RECORD PLANS

STATE OF VERMONT
AGENCY OF TRANSPORTATION

RE-ERECTION OF HISTORIC BRIDGE NO. 18
OVER THE MISSISQUOI RIVER
TOWN OF SWANTON
COUNTY OF FRANKLIN

PLAN

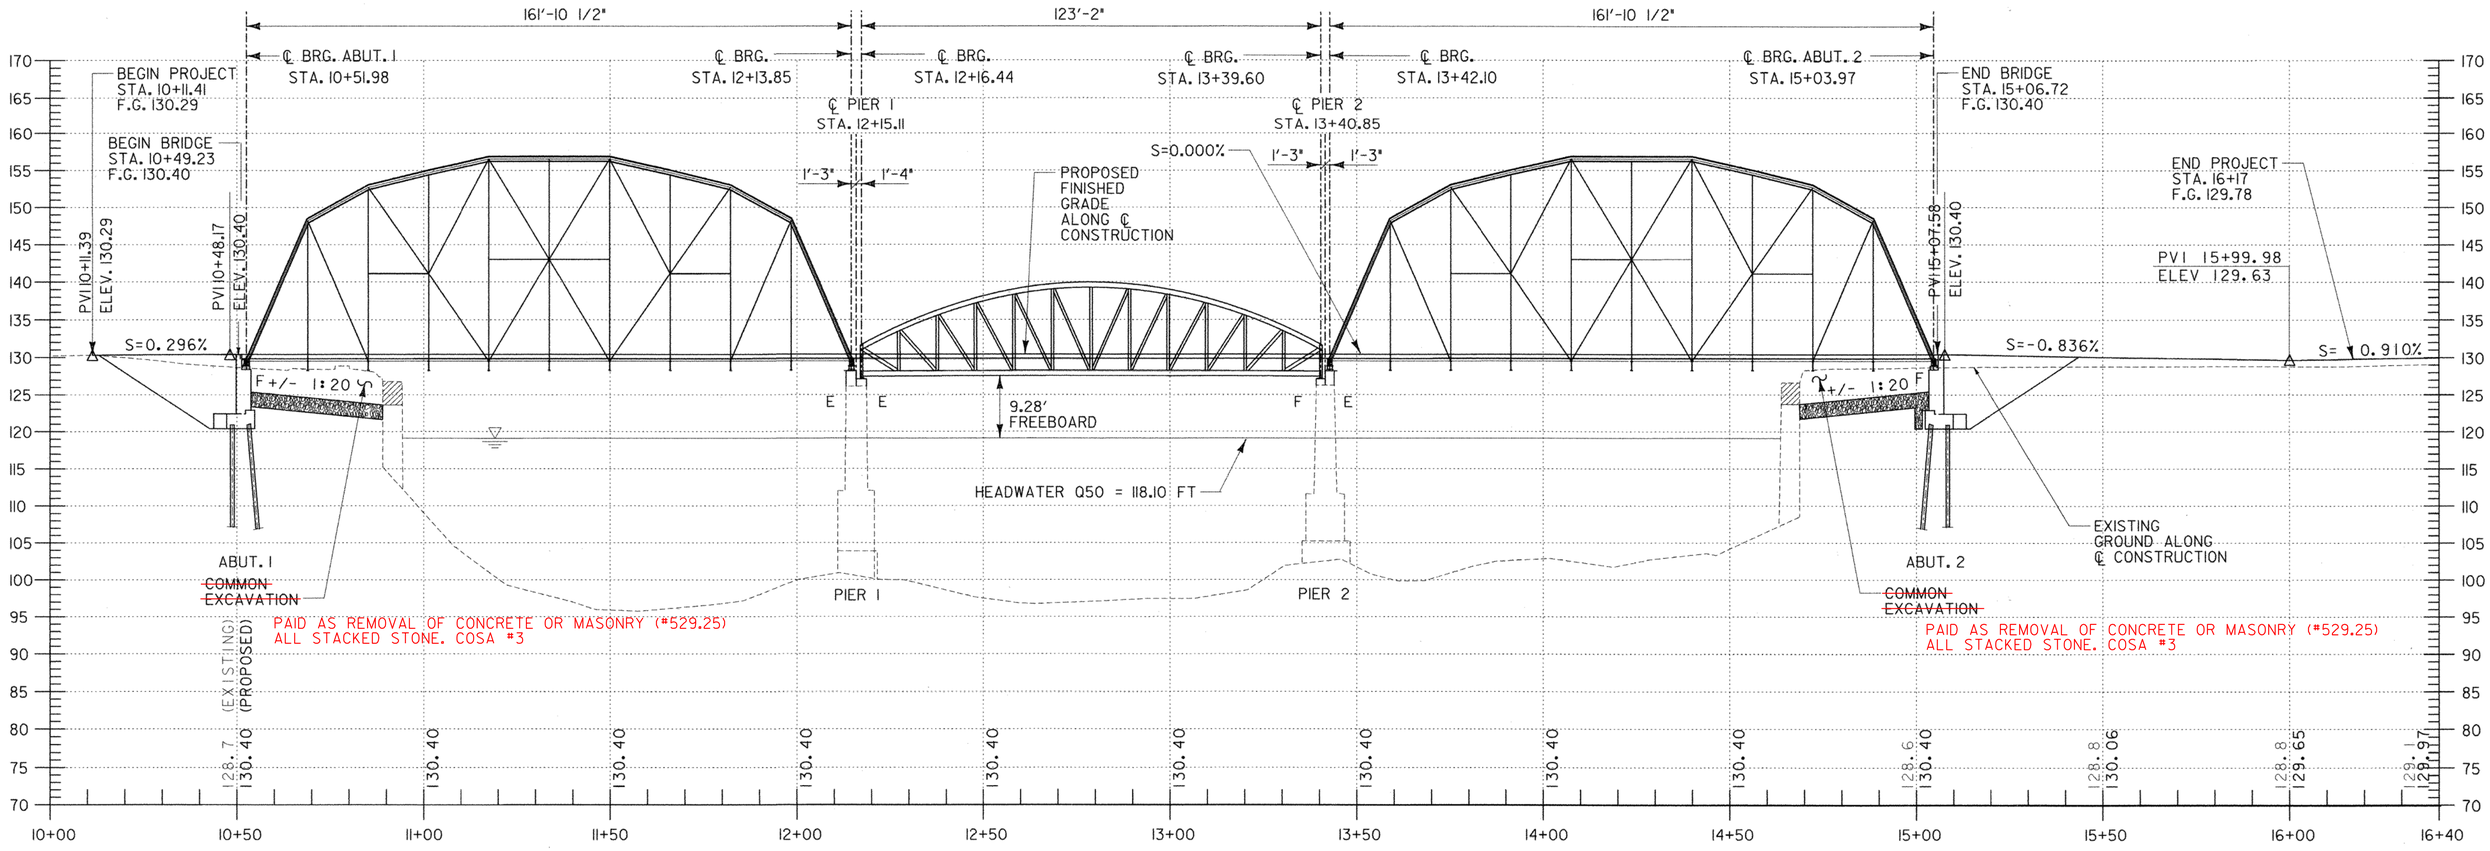
STA. ~~10+46.66~~ 10+47 LT + RT, 10+49 CL } 6 EA SEE CHANGE ORDER #7
STA. ~~15+17.47~~ 15+06 CL, 15+09 LT + RT }

TOP VIEW

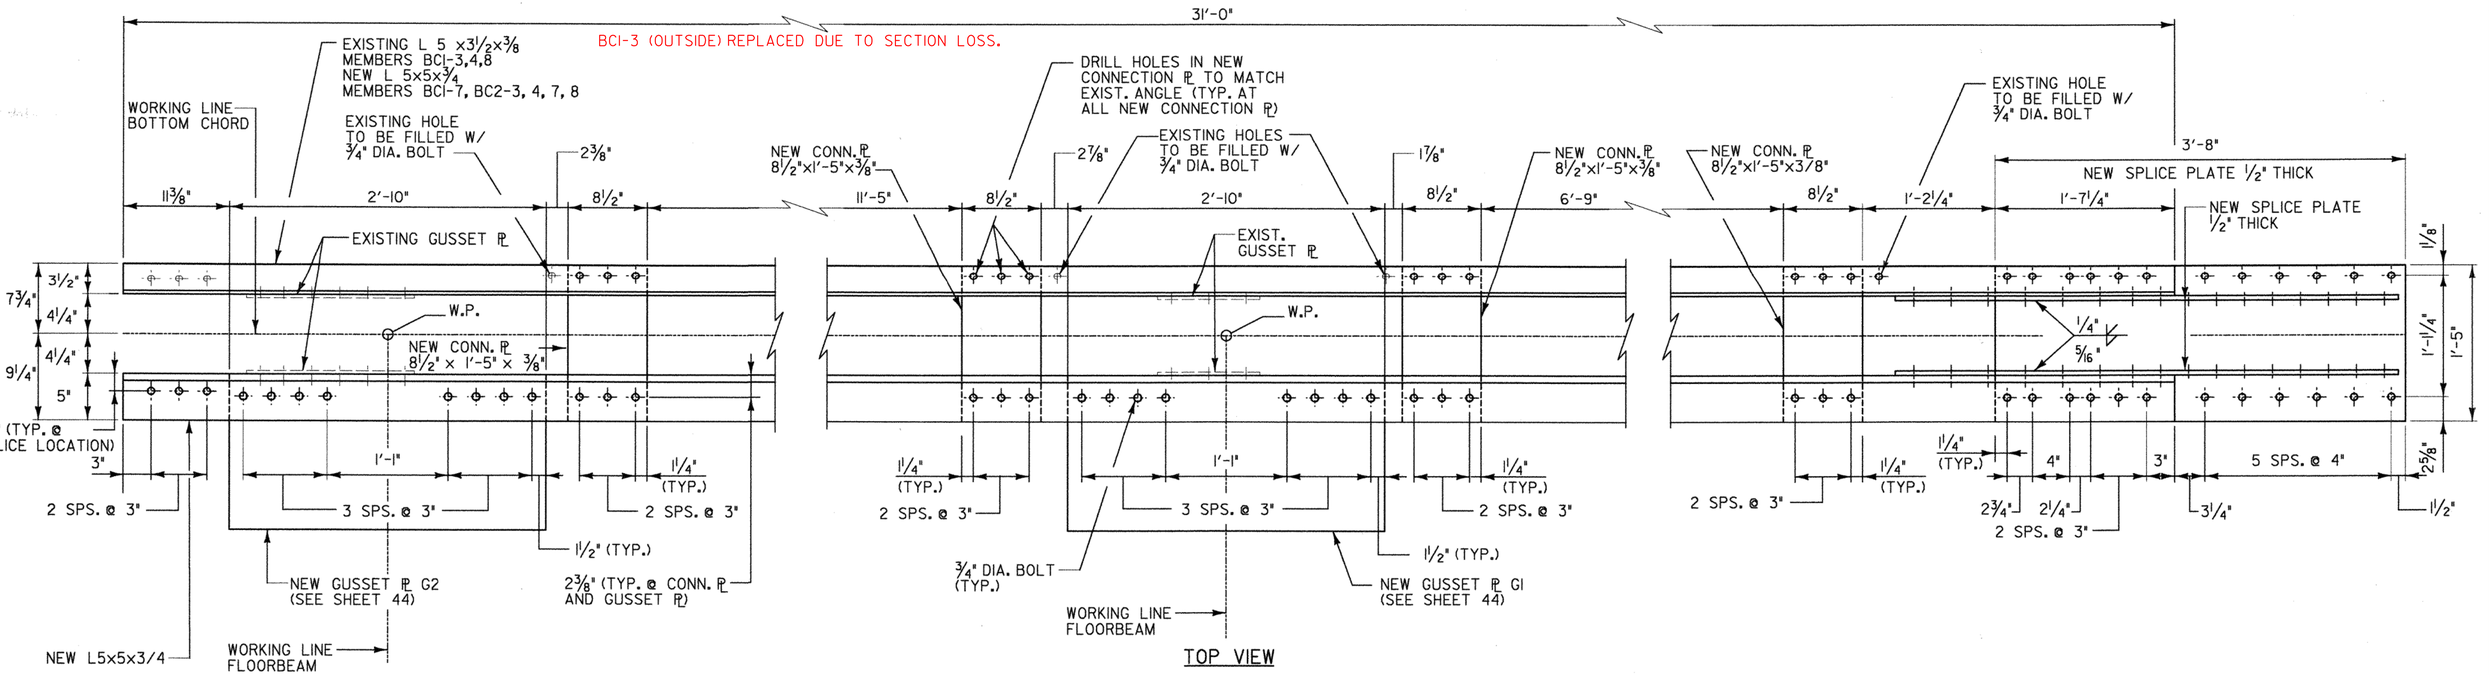
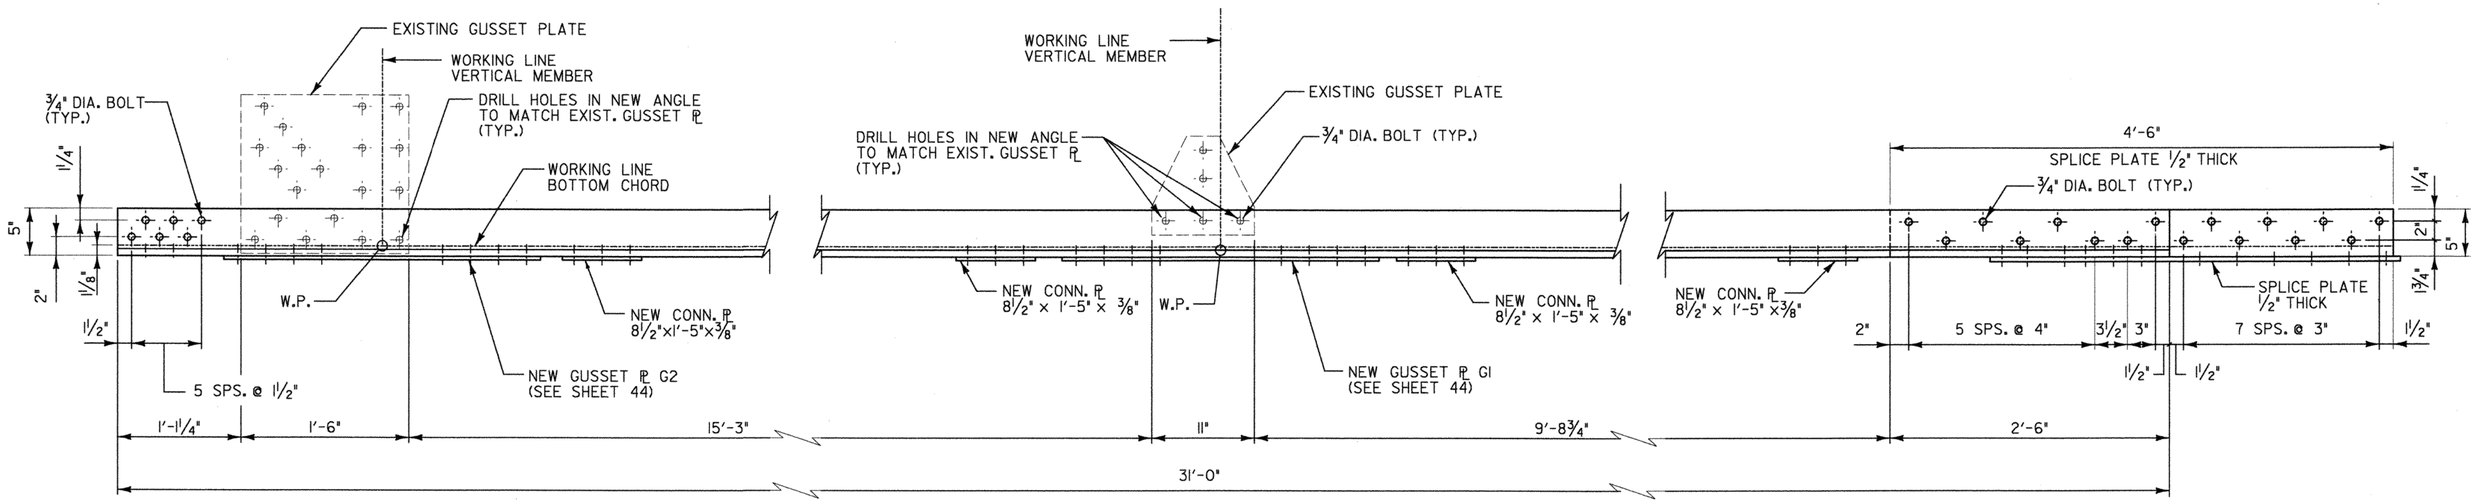
BCI-3 (OUTSIDE) REPLACED DUE TO SECTION LOSS.

VERTICAL MEMBER REPAIR DETAILS

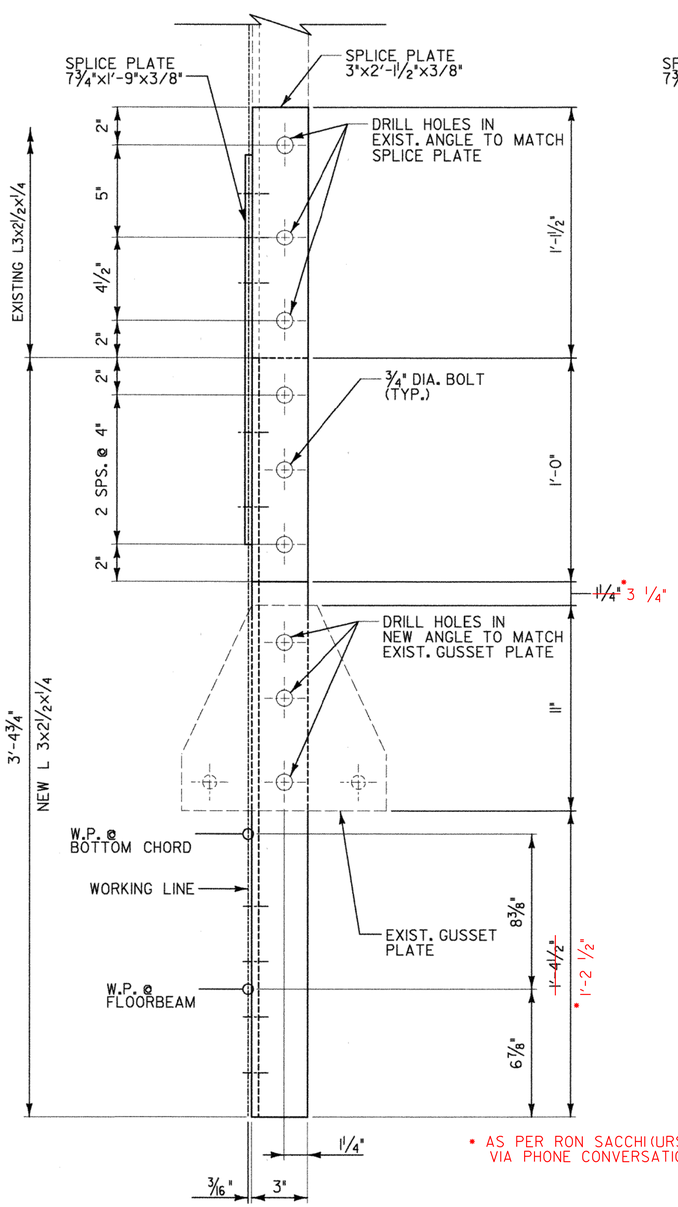
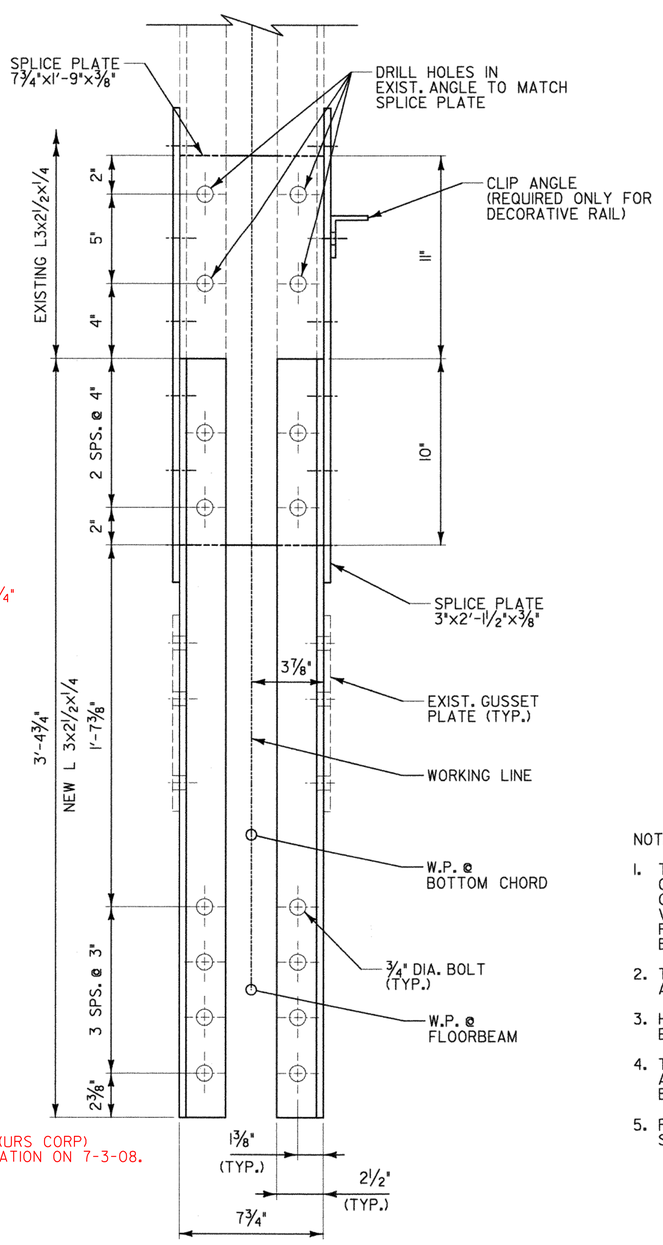
* AS PER RON SACCHI (URS CORP)
VIA PHONE CONVERSATION ON 7-3-08.
